IO-Link Profile

Urgent Corrigendum

**IO-Link Profile –
BLOB Transfer & Firmware Update V1.0**

**Version 1.0
April 2018**

Figure 30 – Device FW-Update state machine

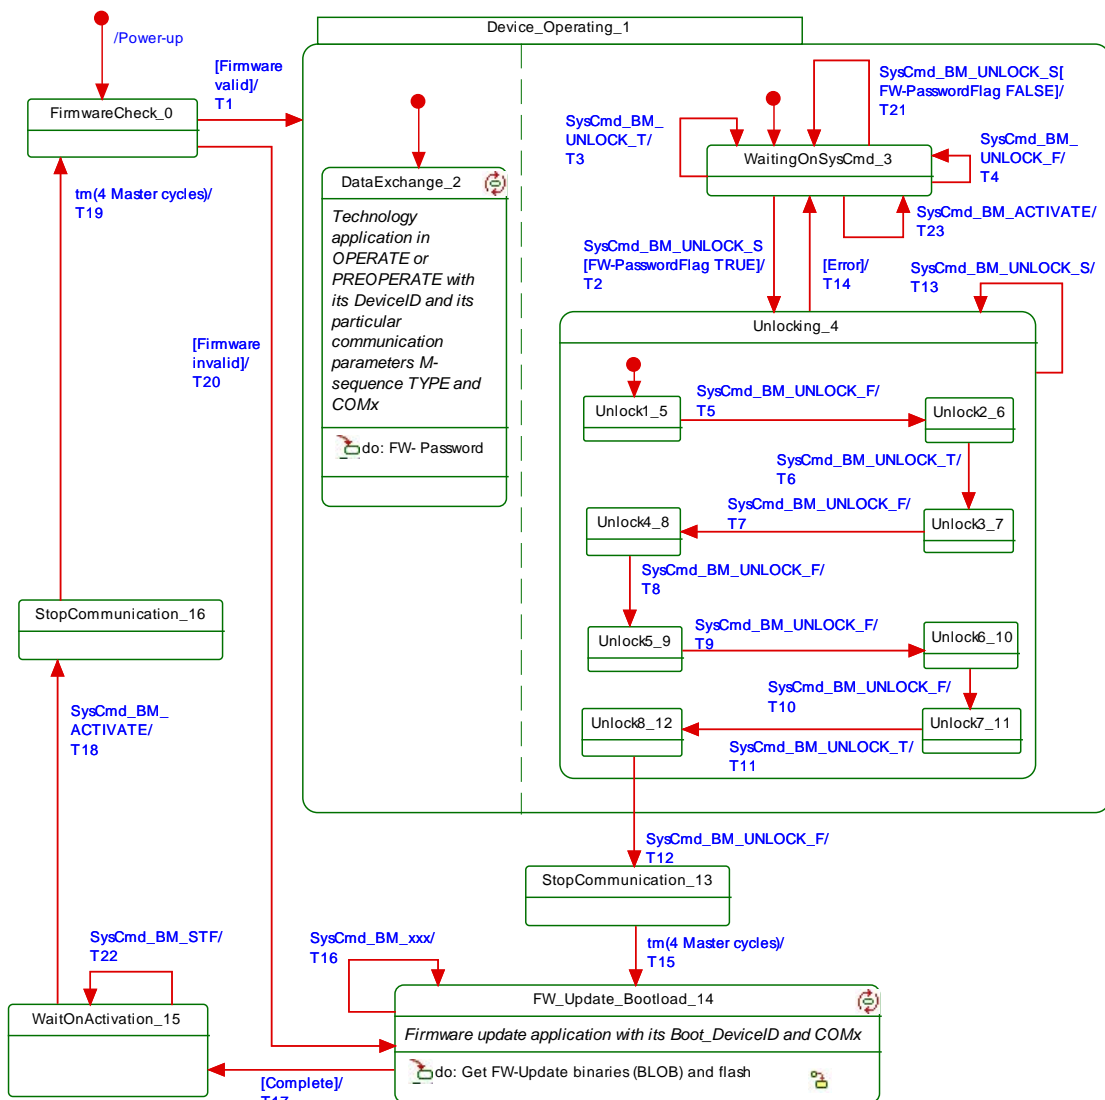
Problems	<ol style="list-style-type: none"> 1. There is no error message specified in case the Unlock sequence is started without setting the FW-Update Flag. 2. There is no error message specified in case the Device is waiting on activation but host sends SysCmd_BM_UNLOCK_S/T/F
Solution	<ol style="list-style-type: none"> 1. Device shall return ErrorCode 0x8036 – "Function temporarily not available", if host sends SysCmd_BM_UNLOCK_S and FW-Update Flag is FALSE (see T21 in new Fig. 30). 2. Device shall return ErrorCode 0x8036 – "Function temporarily not available", if host sends SysCmd_BM_UNLOCK_S/T/F in state WaitOnAcitvation_15 (see T22 in new Fig. 30).
Clauses	7.7 FW-Update protocol
Subclauses	7.7.2 Device FW-Update state machine
Impact on	Device implementation (error handling)
Remark	See PSP-CR-ID 17

Problem	No error message is defined when host sends SysCmd_BM_ACTIVATE before starting the unlock sequence
Solution	Device shall return ErrorCode 0x8036 – "Function temporarily not available" when host sends SysCmd_BM_ACTIVATE in state WaitOnSysCmd_3 (see T23 in new Fig. 30)
Clauses	7.7 FW-Update protocol
Subclauses	7.7.2 Device FW-Update state machine
Impact on	Device implementation (error handling)
Remark	See 4.3 and PSP-CR-ID 19

79 **Figure 2 – Previous and new structure of "BLOB_Last"**

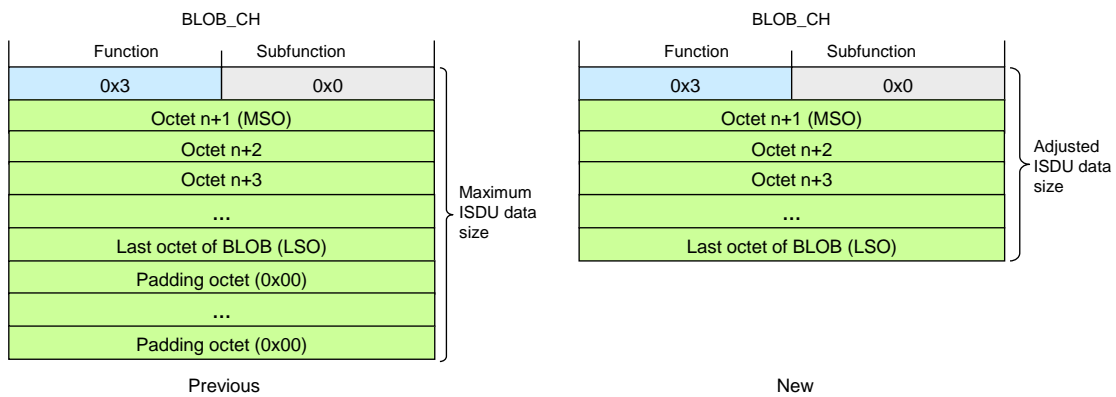
Problem	Specification requires padding octets (0x00) to "fill up the space to maximum ISDU data size", if the size of the entire BLOB is not exact a multiple of the maximum ISDU size. As a consequence, the receiver cannot distinguish between the padding octets (0x00) and a certain number of intended 0x00 octets. The exact end of the payload is required, for example to calculate the CRC signature.
Solution	The host shall use the maximum possible ISDU size. Padding octets shall not be used. The last ISDU shall have the length of the remaining octets of the BLOB including the BLOB_CH header.
Clauses	6.5 BLOB parameters and transfer
Subclauses	6.5.3.5 BLOB_Last
Impact on	BLOB transfer tools and Device implementations
Remark	See PSP-CR-ID 21
